Volume V

Appendix G.4

Group 1 Matrix Brief on Maintenance, Material, and Management

Group 1 Investigation Matrix

LH2-IT Geometry

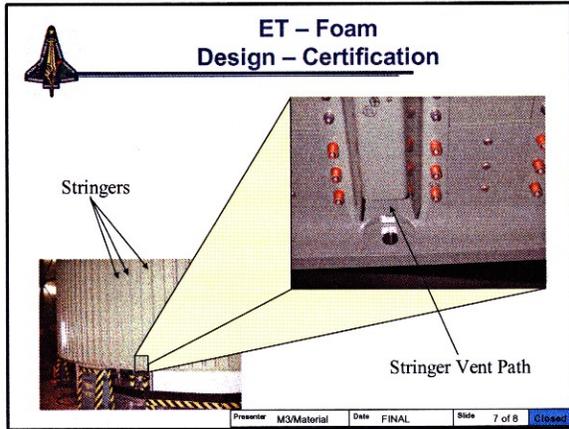
- **Action / Issue:** Geometry of the LH2-IT flange could contribute to foam loss
- **Background / Facts:**
 - LH2-IT geometry provides several paths where LN2 can possibly get into the flange area
 - Solid N2 to GN2 state transitions could possibly contribute to foam loss
 - A “Y” joint is formed where the LH2-IT connection is made provide a reservoir where LN2 can collect

- **Findings:**
 - Bolt holes, shim gaps and stringer venting could provide a path for LN2 to get behind the foam in the flange closeout area
 - During ascent, stresses in flange area change between tension and compression
 - LN2 path back to the IT could possibly be sealed leading to foam being “popped” off
 - Foam loss from the LH2-IT flange region has been observed on ~70% of missions where imagery was available
